General Bid Bulletin No. 16
23 July 2021

**THE MALOLOS-CLARK RAILWAY PROJECT AND THE NORTH-SOUTH RAILWAY
PROJECT SOUTH LINE COMMUTER PACKAGE CP NS-01: PROCUREMENT OF
ELECTRICAL AND MECHANICAL SYSTEMS AND TRACK WORKS (IFB No: 21-040-3)**

This General Bid Bulletin is issued to amend/clarify certain provisions in the Bidding Documents for the above-mentioned Project. Please refer to the attached Annexes of this General Bid Bulletin for details:

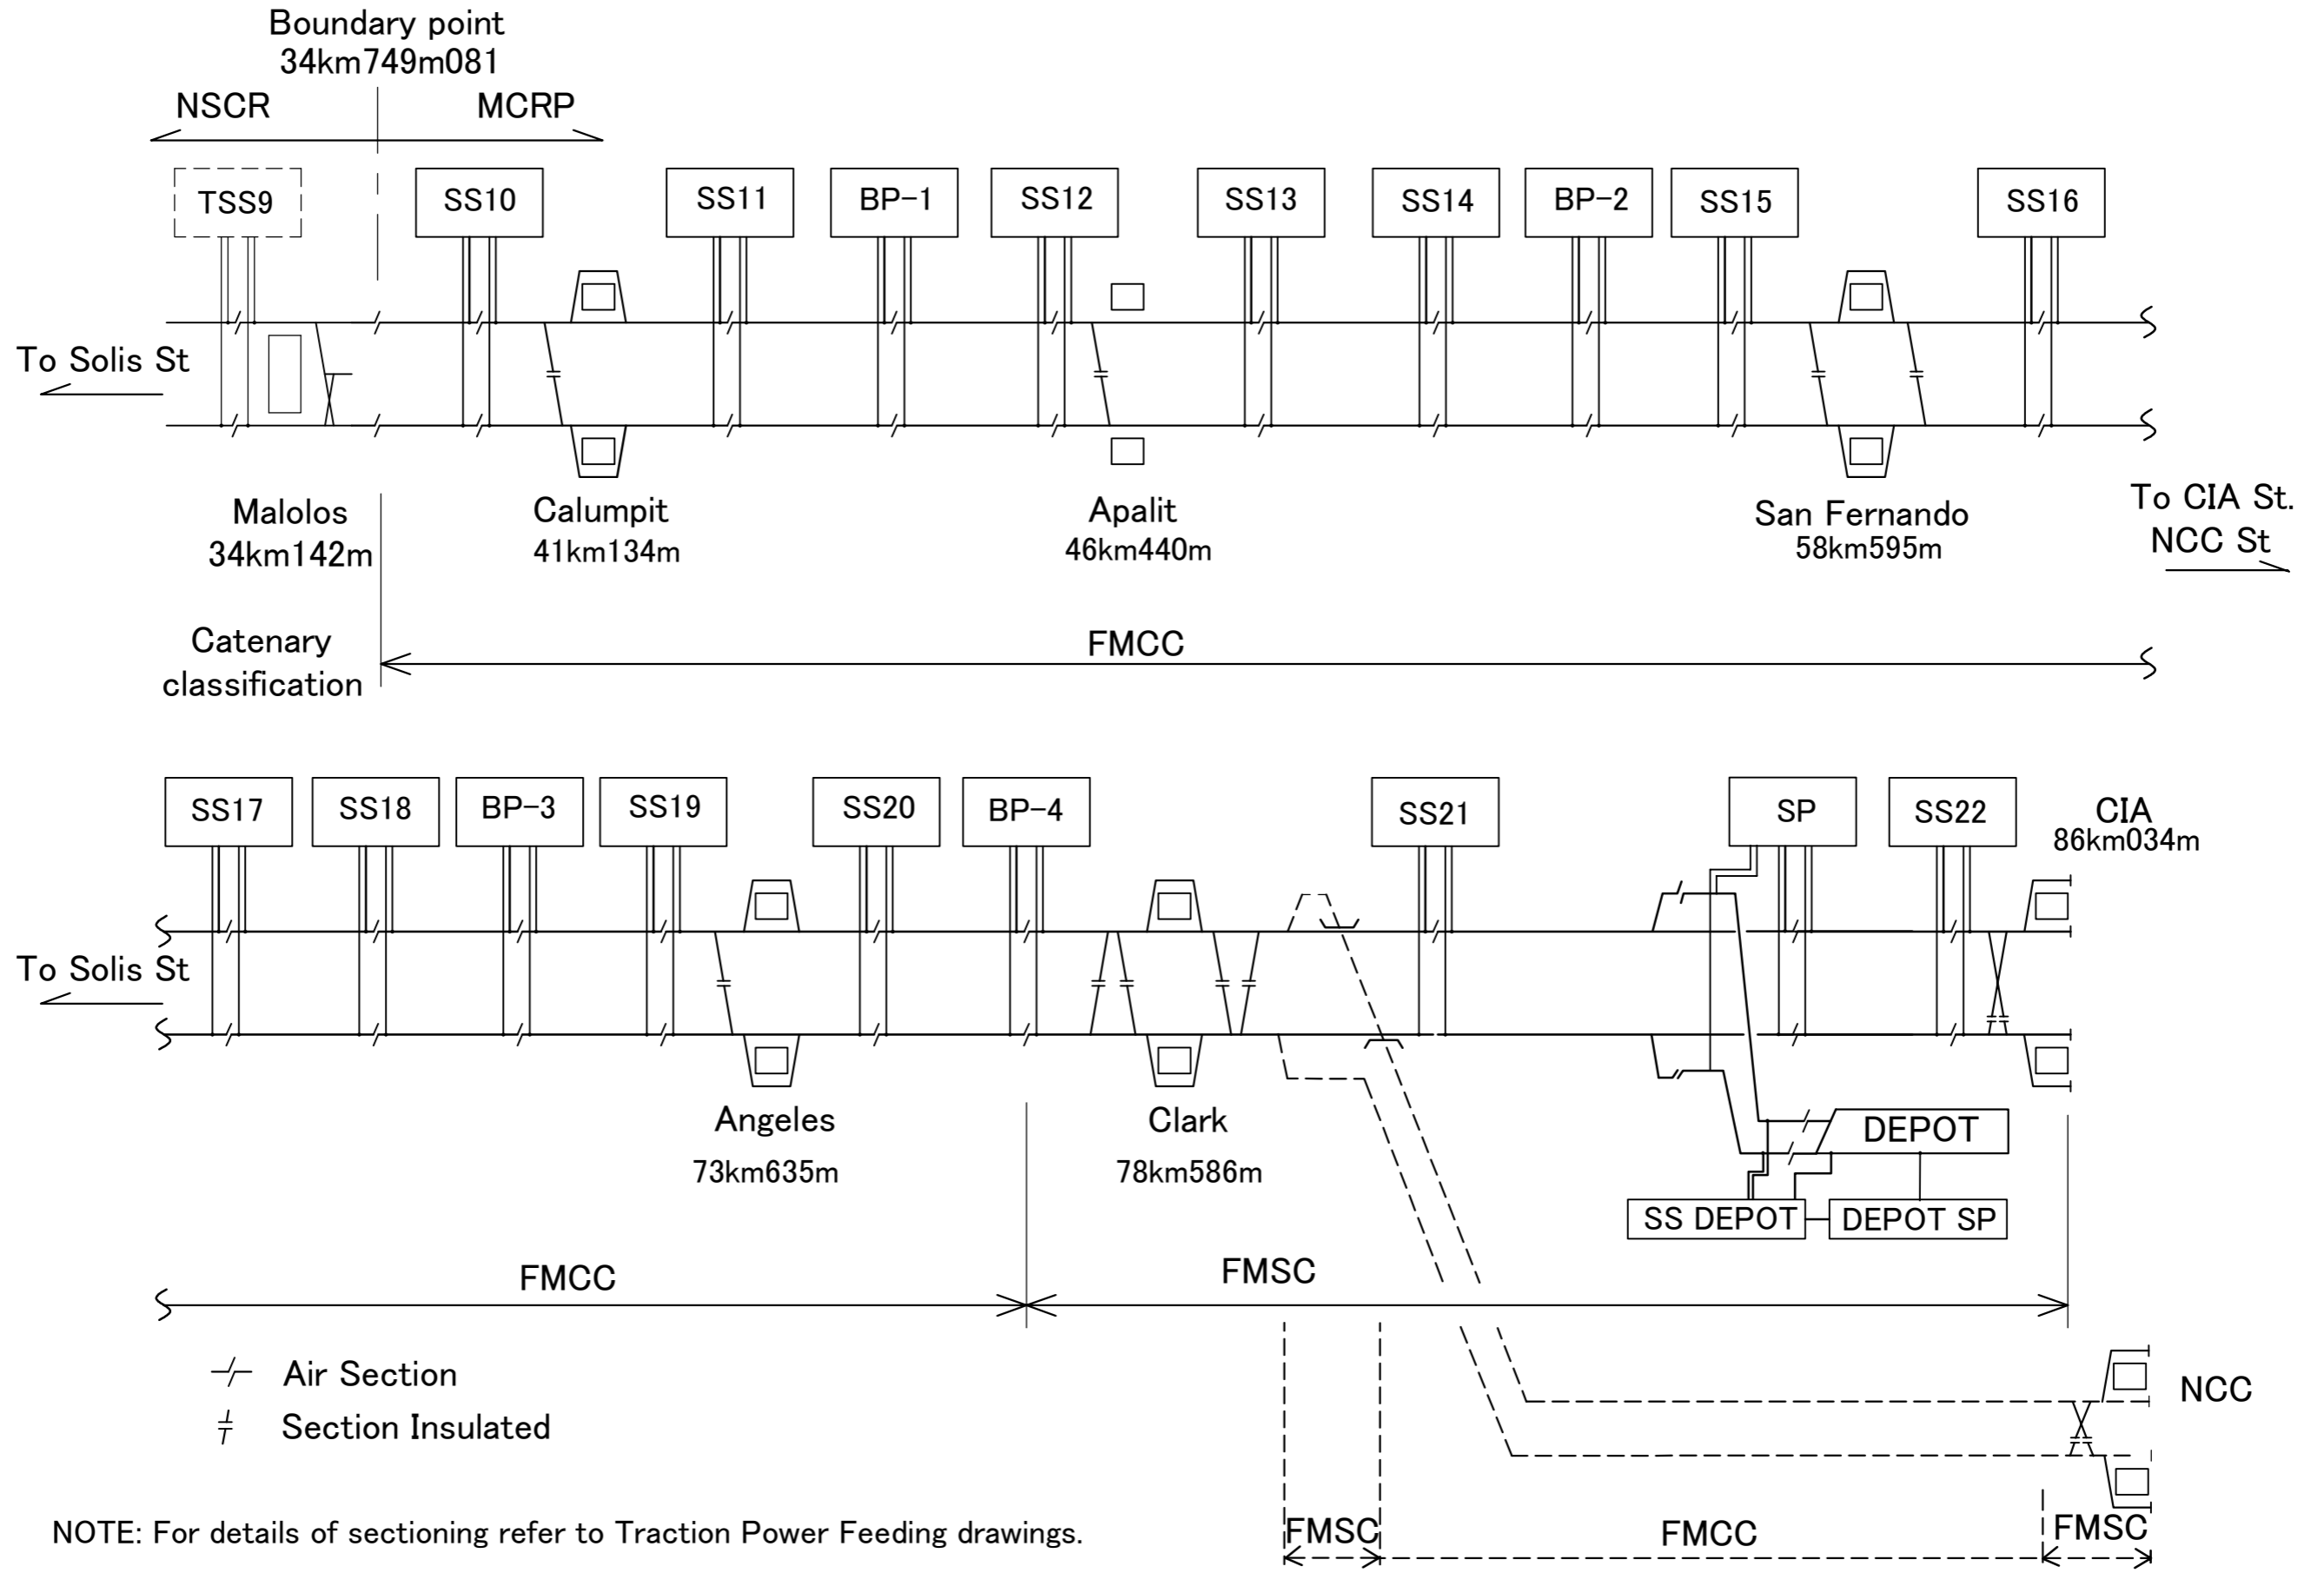
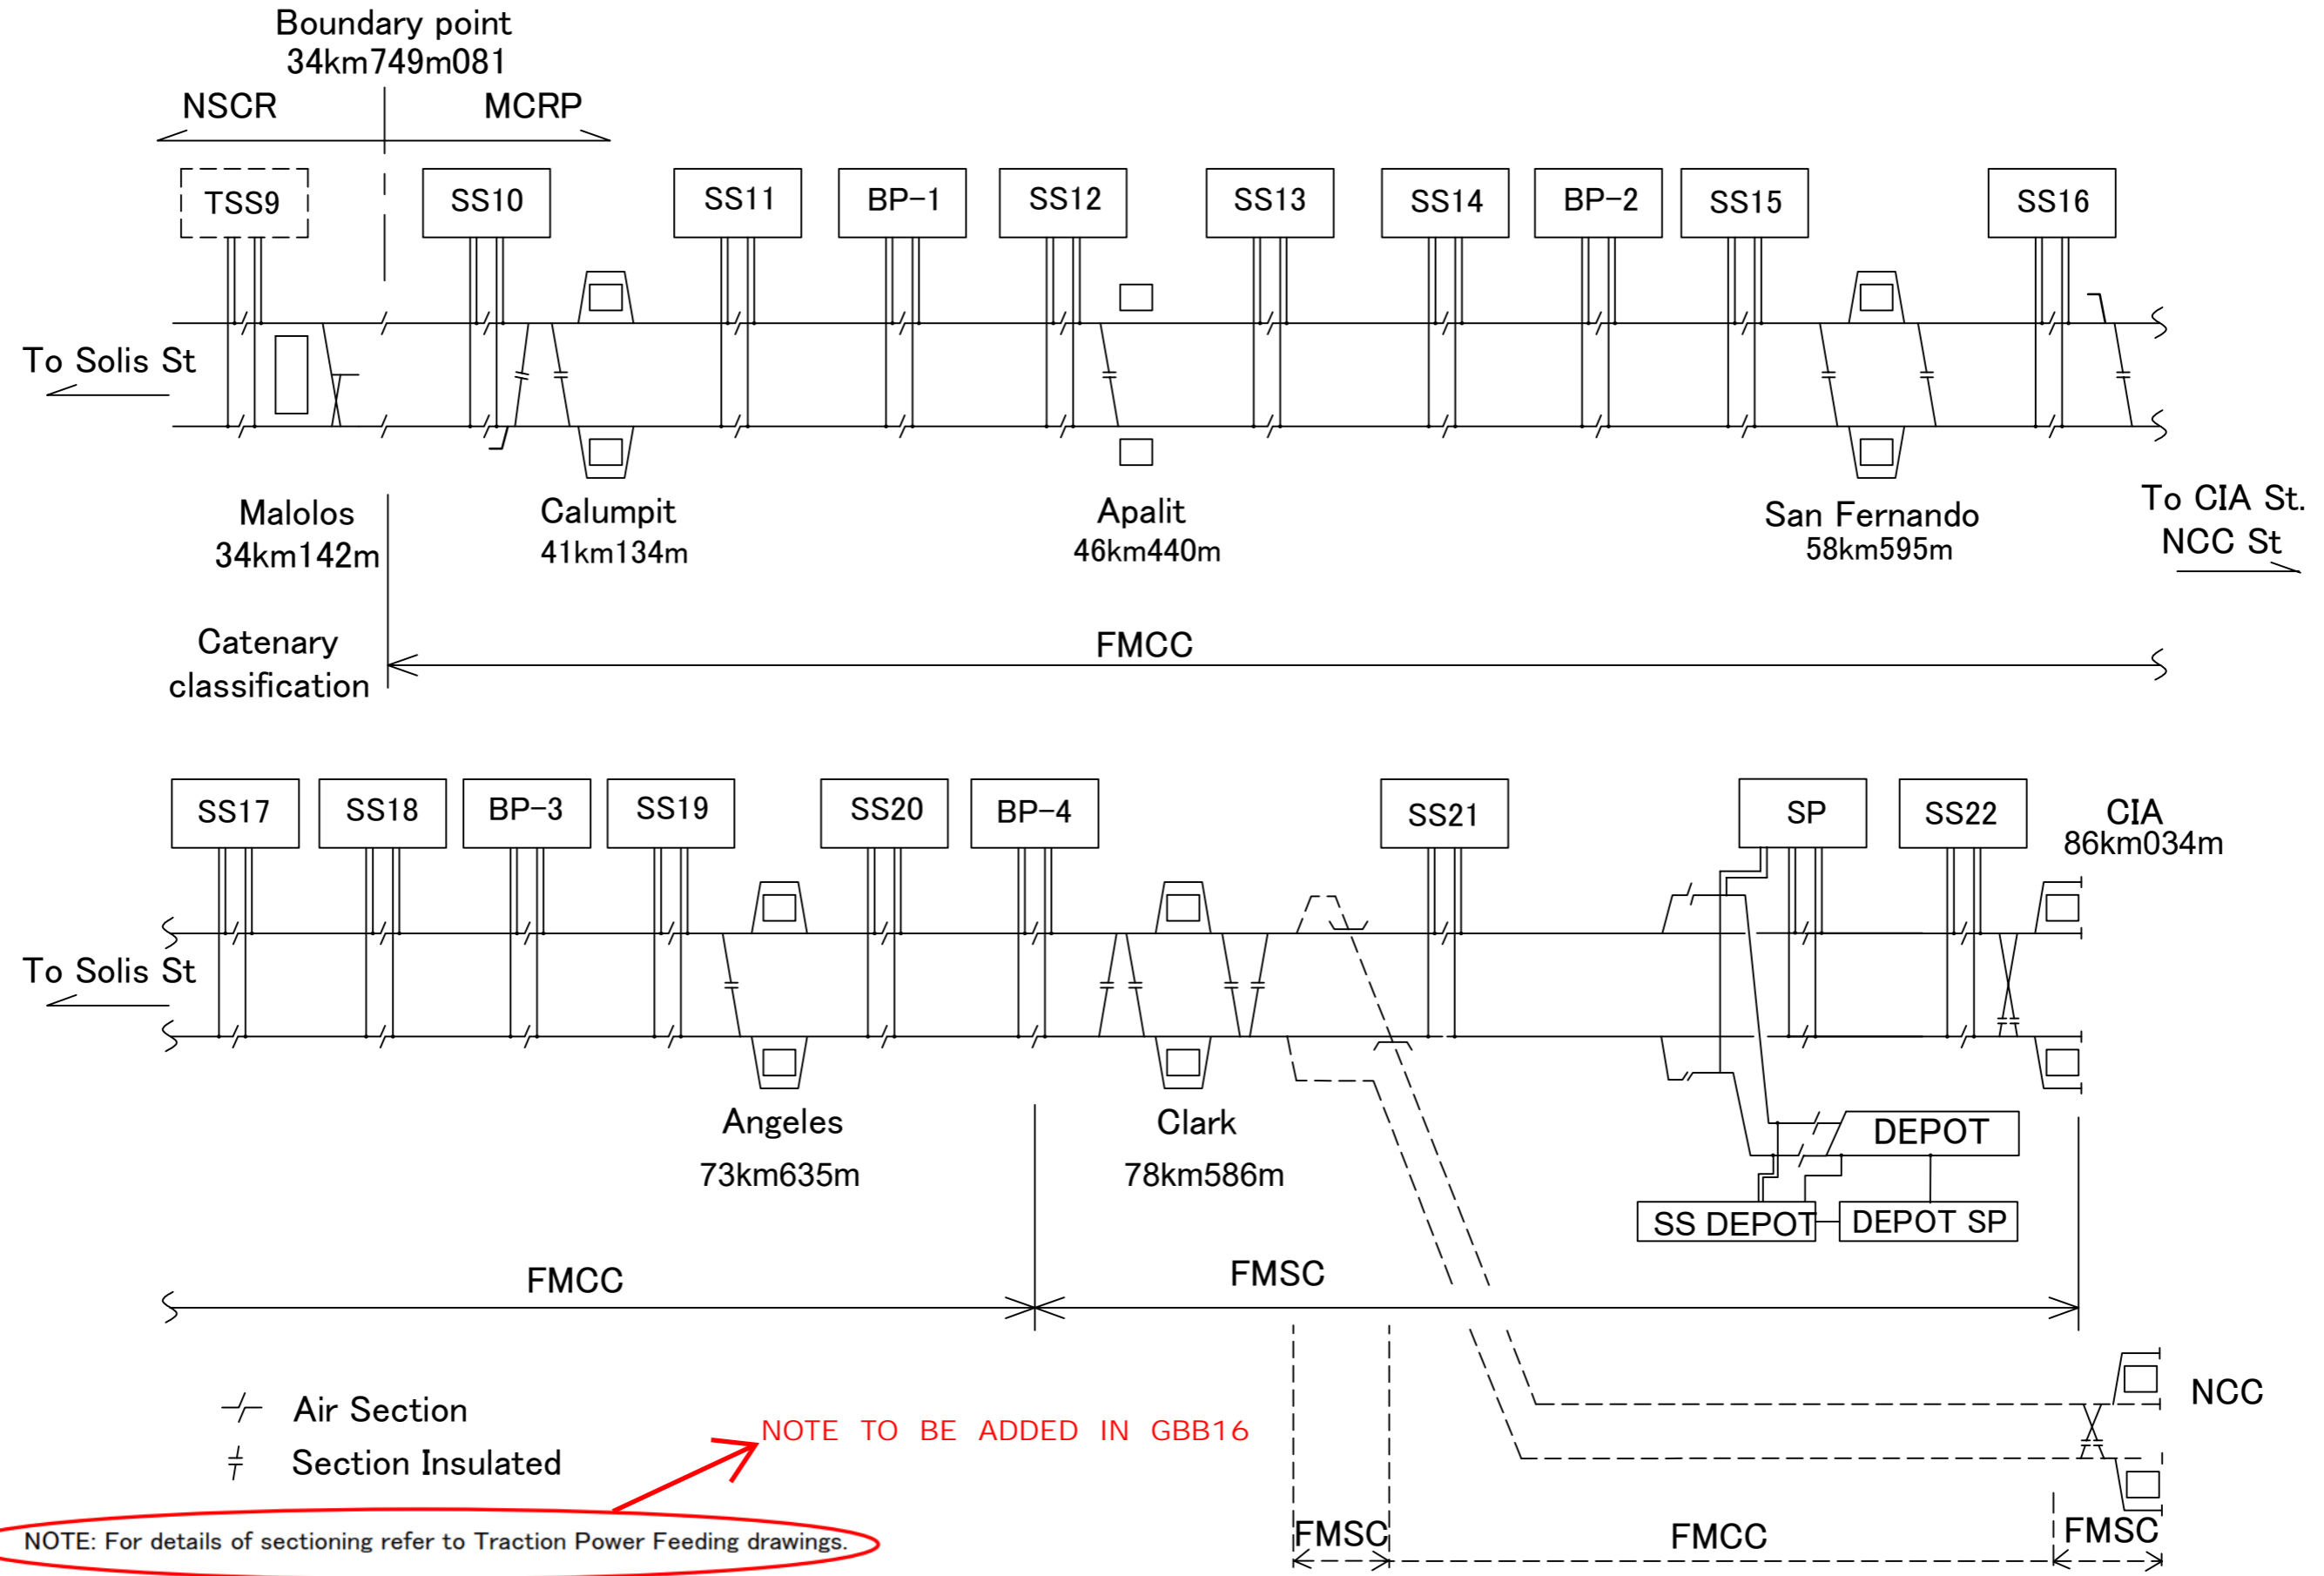
24	NSCR-GCR-NS01-ZWE-DWG-DS-000002 GBB 4, page 351	Lightning Arrester Detail issued in GBB 4 is replaced by NSCR-GCR-NS01-ZWE-DWG-DS-000002 Rev. 01
25	NSRP-South-DWG-X/X-OCS-0002 Rev. 04 GBB 12, page 239	Revised the drawing issued in GBB12 with drawing "NSRP-South-DWG-X/X-OCS-0002 Rev. 06"
26	MCRP-DWG-X/X-OCS-0002 Rev. 04 GBB 12, page 237	Revised the drawing issued in GBB12 with drawing "MCRP-DWG-X/X-OCS-0002 Rev. 05"

NOTE TO BE ADDED IN GBB16

NOTE: For details of sectioning refer to Traction Power Feeding drawings.
